SUBJECT: H. B. ROBINSON STEAM ELECTRIC PLANT, UNIT NO. 2 – ISSUANCE OF AMENDMENT TO REVISE REACTOR COOLANT SYSTEM PRESSURE AND TEMPERATURE LIMITS APPLICABLE FOR 50 EFFECTIVE FULL POWER YEARS (CAC NO. MF7048)

Amendment No. 248  
Renewed License No. DPR-23

SAFETY EVALUATION BY THE OFFICE OF NUCLEAR REACTOR REGULATION

H. B. ROBINSON STEAM ELECTRIC PLANT, UNIT NO. 2

Figure 3.4.3-1  
 Reactor Coolant System Heatup Limits  
 Applicable Up to 50 EFPY

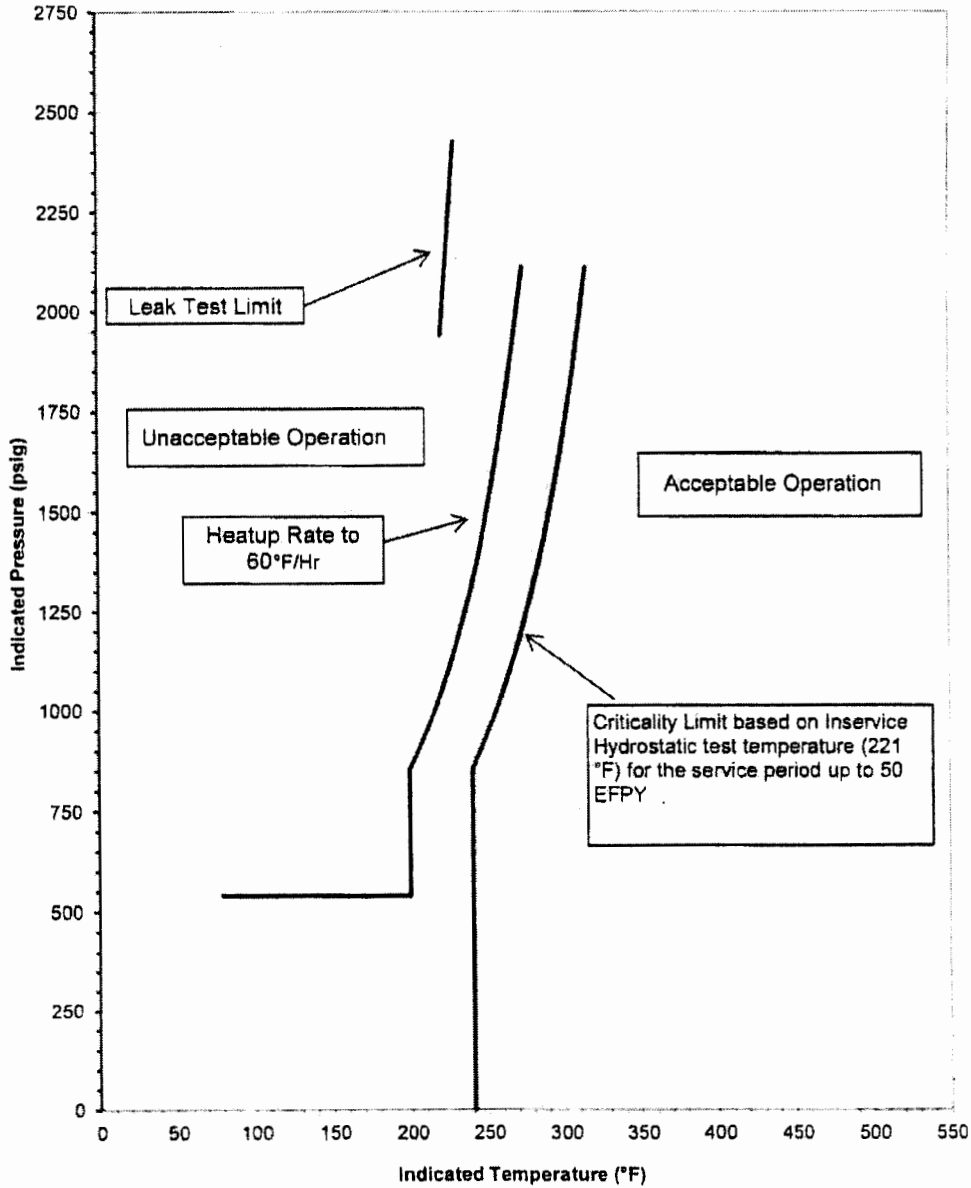
The U.S. Nuclear Regulatory Commission has issued the enclosed Amendment No. 248 to Renewed Facility Operating License No. DPR-23 for the H. B. Robinson Steam Electric Plant, Unit No. 2 (HBRSEP2). This amendment changes the HBRSEP2 Technical Specifications (TSs) in response to your application dated November 2, 2015, as supplemented by letters dated December 22, 2015; and March 31, May 9, and September 14, 2016. The amendment revises the reactor coolant system (RCS) pressure and temperature limits by replacing TS Section 3.4.3, "RCS Pressure and Temperature (P/T) Limits," Figures 3.4.3-1 and 3.4.3-2, with figures that are applicable up to 50 effective full power years.

SR 3.4.3.1 verifies that that RCS operation is within the limits of Figures 3.4.3-1 and 3.4.3-2 when RCS pressure and temperature conditions are undergoing planned changes. The LAR extends the applicability of the P-T limits to 50 EFPY, which does not impact the function of SR 3.4.3.1 to verify that the RCS is operated within approved P-T limits. Therefore, the NRC staff finds the use of the revised Figures 3.4.3-1 and 3.4.3-2 in SR 3.4.3.1 meets 50.36(c)(3) by providing sufficient test, calibration, or inspection requirements to assure that the necessary quality of systems and components is maintained, that facility operation will be within safety limits, and that the LCOs will be met.

Controlling Material: Upper Shell Plate W10201-1 & Girth Weld 10-273  
 Limiting ART Values at 50 EFPY: 1/4T, 172°F & 263°F  
 3/4T, 153°F & 191°F

Curves applicable for heatup rates up to 60°F/Hr for service period up to 50 EFPY  
 Heatup Curves include +20°F and -80 psig Allowance for Instrumentation error.

The NRC staff evaluated the licensee's proposed 50 EFY P-T limit curves by independently calculating P-T limit curves based on the governing equation in Appendix G to Section XI of the ASME Code, but with  $K_{it}$  computed from a 1-dimensional thermal stress analysis across a vessel wall and the allowable pressure computed from a method similar to that used in Section 2.6, "Pressure-Temperature Curve Generation Methodology," of WCAP-14040-NP-A. The NRC staff's calculations included verifying that (1) the requirements in Table 1 "Pressure and Temperature Requirements for the Reactor Pressure Vessel" of Section IV.A of Appendix G to 10 CFR Part 50 and (2) the instrumentation errors specified in the licensee's submittal were correctly applied. The NRC staff also verified that for the lower temperature range of the cooldown P-T limit curve, the limiting material is the Upper Shell Plate W10201-1 and for the higher temperature range, the limiting material is the Circumferential Weld Seam 10-273 as reflected in Table 28 "50 EFY Cooldown Curve Data Points Using 1996 App. G" of WCAP-15827. Based on these confirmatory calculations, the NRC staff finds the licensee's proposed 50 EFY heatup and cooldown curves (including the leak test and criticality limits) reflected in the revised Figure 3.4.3-1, "Reactor Coolant System Heatup Limits Applicable Up to 50 EFY," and revised Figure 3.4.3-2, "Reactor Coolant System Cooldown Limitations Applicable Up to 50 EFY," respectively, of the HBRSEP2 TSs included in Attachments 2 and 3 of the LAR (Reference 1), acceptable.
